CALIFORNIA COASTAL COMMISSION

STAFF REPORT AND RECOMMENDATION ON APPEAL SUBSTANTIAL ISSUE DETERMINATION

Appeal Number: A-6-PSD-17-0003

Location: 1360 North Harbor Drive, San Diego, San Diego County

FIGURE 4b
Portside Pier Floor Plans (Second Floor)
Revised Version

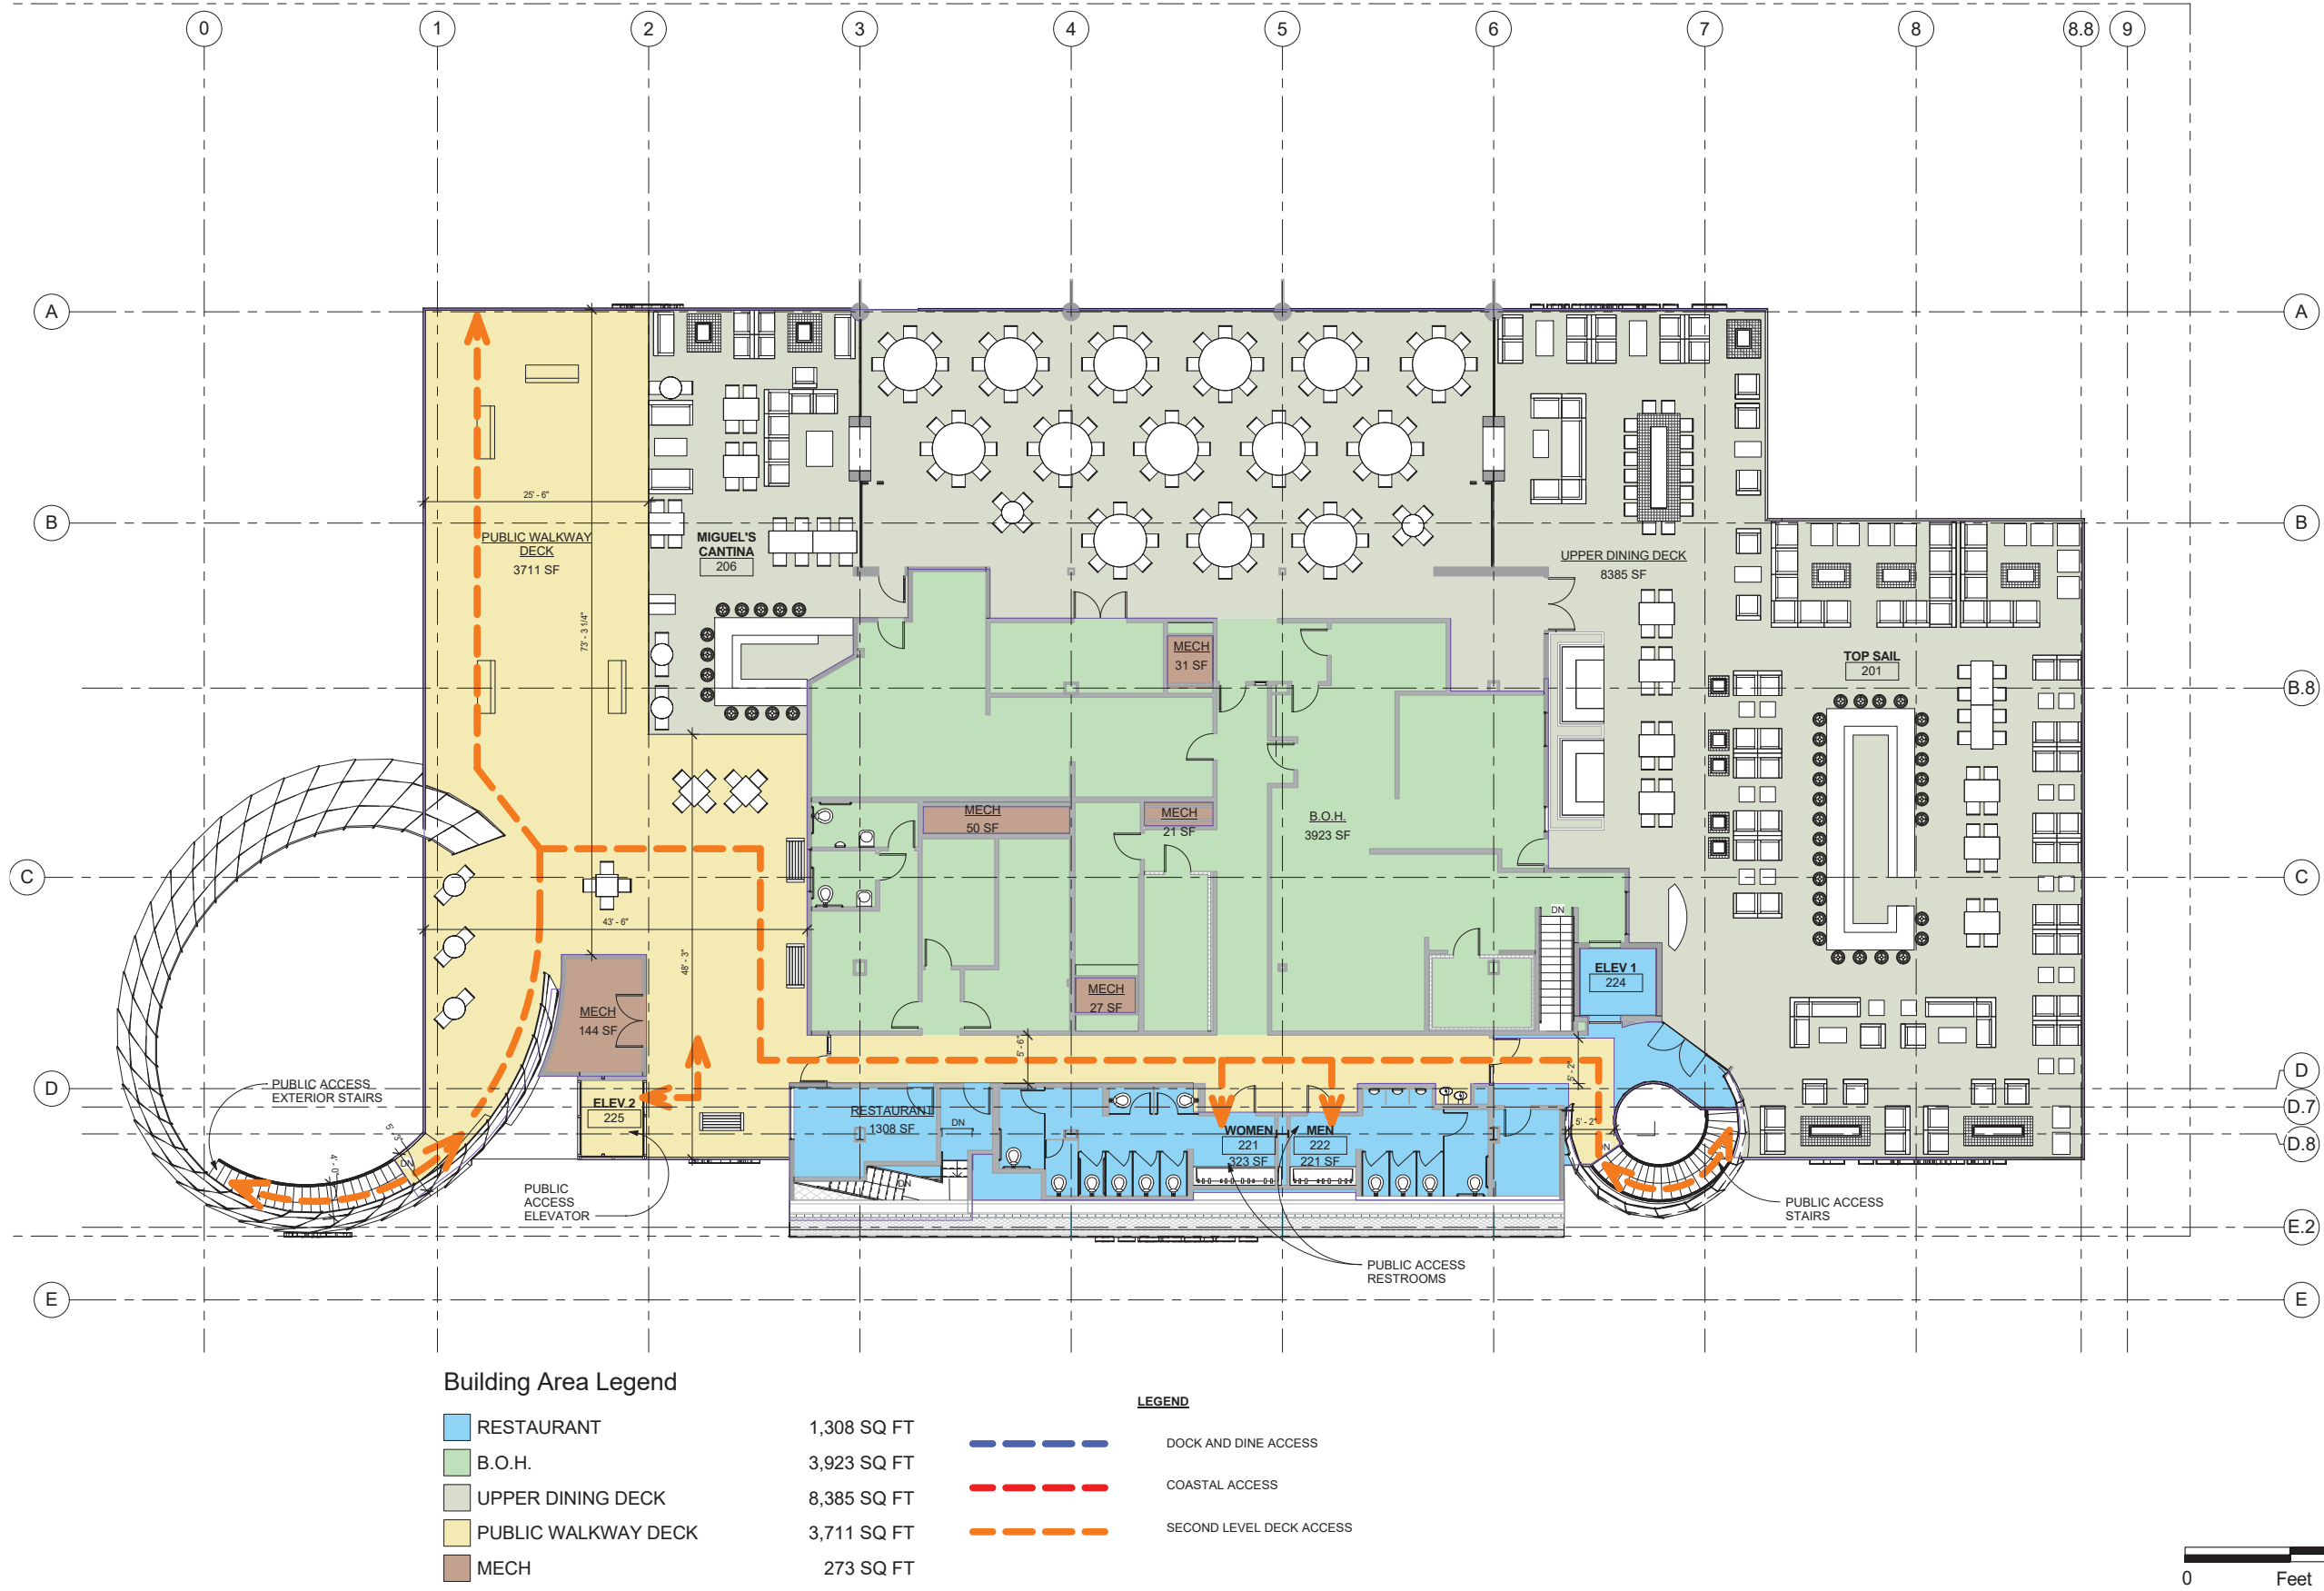
In addition, at our May 4, 2016 meeting, the subject project was presented with a continuous public walkway around the perimeter of the ground floor. It is unclear if the feature has since been removed, as the floor plans in Figure 4a of the MND instead shows seating around the perimeter of the ground floor. The inclusion of a continuous walkway design around the perimeter of the building platform is necessary to increase coastal access at the site and recapture public views. Any public space should also be separate from private areas so that the public feels welcomed and not as if they are intruding in the private restaurant space.

In addition, at our May 4, 2016 meeting, the subject project was presented with a continuous public walkway around the perimeter of the ground floor. It is unclear if the feature has since been removed, as the floor plans in Figure 4a of the MND instead shows seating around the perimeter of the ground floor. The inclusion of a continuous walkway design around the perimeter of the building platform is necessary to increase coastal access at the site and recapture public views. Any public space should also be separate from private areas so that the public feels welcomed and not as if they are intruding in the private restaurant space.

Response to Comment D-17: Figure 4a has been revised to show a continuous public walkway around the perimeter of the ground floor, consistent with Figure 6 of the Draft MND, which was the intent of the proposed project. Draft MND Figure 6 was removed from the final document because Figures 4a and 4b were updated to include the coastal access routes. Therefore, Figures 4a and 4b have also been updated to include public access routes, the new elevator, revisions to the second level public viewing deck, and locations of public access signage. Clarifying language has been added to Section II., Project Description, of the Final MND has been added as follows (additions in underline):

“Additionally, a perimeter walkway around the bottom floor of the building would be open to the public to provide views of the bay. Clear signage would be provided directing the public from the North Embarcadero Promenade to the public viewing deck and to the perimeter walkway (see Figure 4a).”

Additionally, this project revision will be reflected in the proposed non-appealable CDP. This project revision does not require recirculation of the Draft MND as it does not constitute a substantial revision to the MND. The project proposed a continuous public walkway around the perimeter of the ground floor, as shown on the Draft MND Figure 6, and this is just a clarification as Figure 4a in the Draft MND inaccurately depicted restaurant seating at the edge of this walkway. Figure 4a has been revised to include the coastal access on the ground floor and Figure 4b has also been updated to include the second-floor public access. Together the revised Figures 4a and 4b replace Figure 6, which has been eliminated in the Final MND.
